**REQUEST FOR INFORMATION (RFI)
VA250-16-B-0589**

PROJECT NUMBER:	553-304	Please ensure that before submitting questions or requests for clarification that you thoroughly read the solicitation, specifications, drawings and other pertinent documents. When submitting questions on this project the Government requires contractors to specifically identify the specification and/or solicitation section(s) or drawing number(s) in reference to the question or request for clarification submitted. No question or request for clarification will be answered by the Government unless the above requirements are met. Failure to comply may prevent the Government from responding in a timely manner.	
PROJECT TITLE:	Renovate South Lobby		
PROJECT LOCATION:	Department of Veterans Affairs John D. Dingell, VA Medical Center 4646 John R. Street Detroit, MI 48201-1916		
SUBMITTED BY:	Antler Construction	City/State:	Canton, MI
PHONE NO.:	734-404-6459

RFI NO.:1	DATE:11/18/2016	SPEC/DWG. REFERENCE:
REPLY NEEDED BY:

Revised key plan.

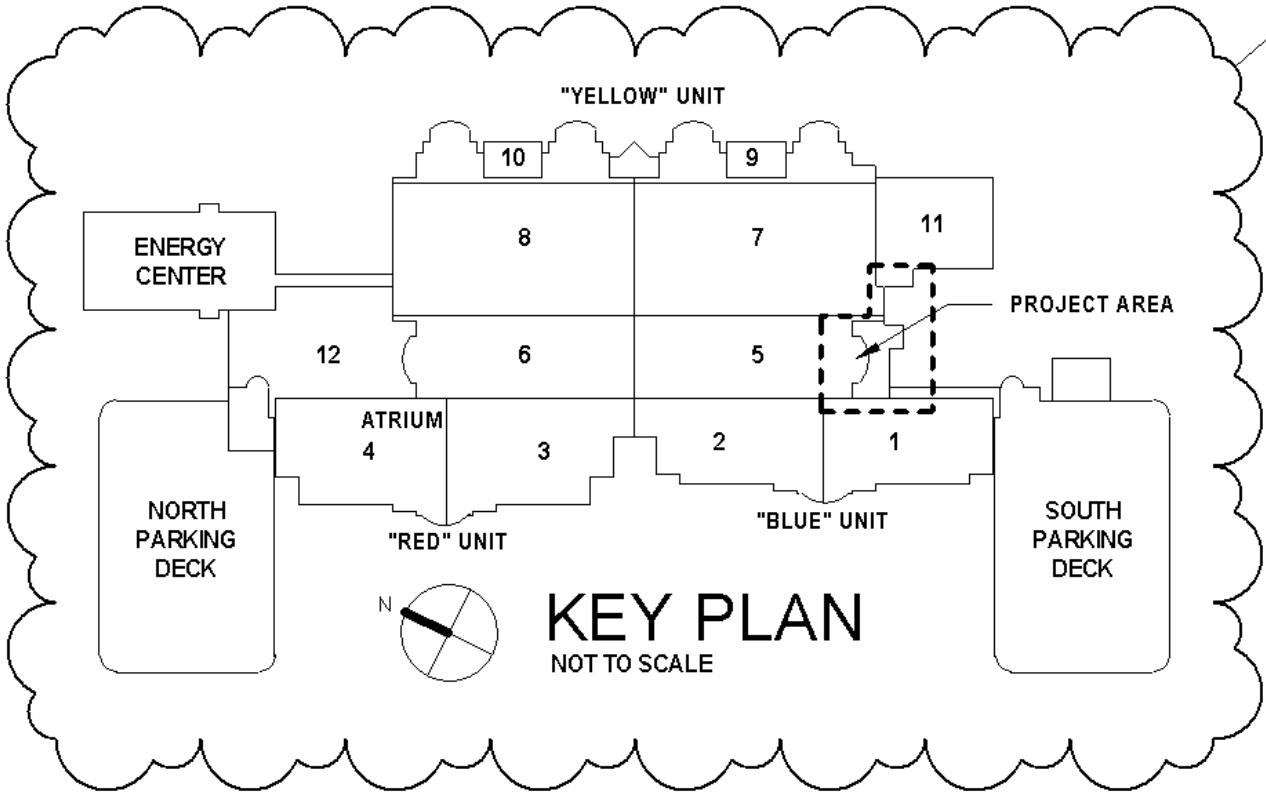
5. Project area shown on G-001 is incorrect. **See attached revised key plan.**
6. Area 2 is to be all night and weekend work? **This area must remain open to the public during "open" hours.**
